REMARKS

Serial No. 10/627,689

AMENDMENTS TO THE DRAWINGS:

FIG. 1

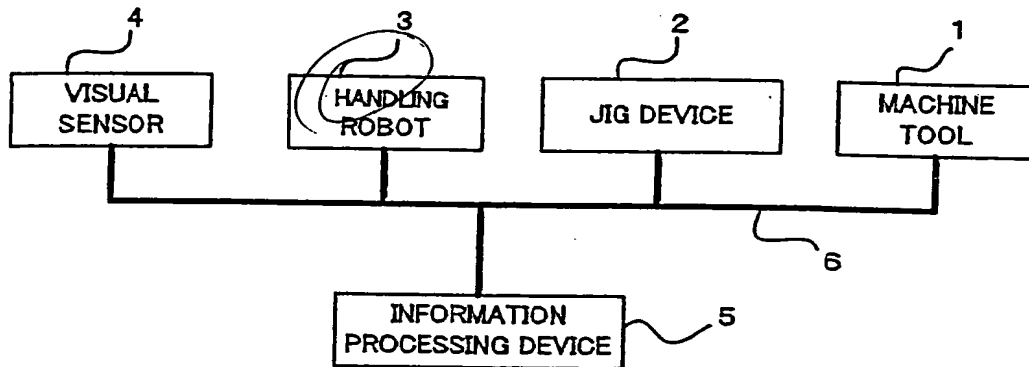
In the Office Action at item 5, the Examiner objected to the drawings. In order to overcome these objections, replacement figures are submitted herewith. In FIGS. 1 and 5, respectively, the spelling errors have been corrected. For the convenience of the Examiner, an annotated sheet showing the changes made is attached. Approval of these changes to the Drawings is respectfully requested.
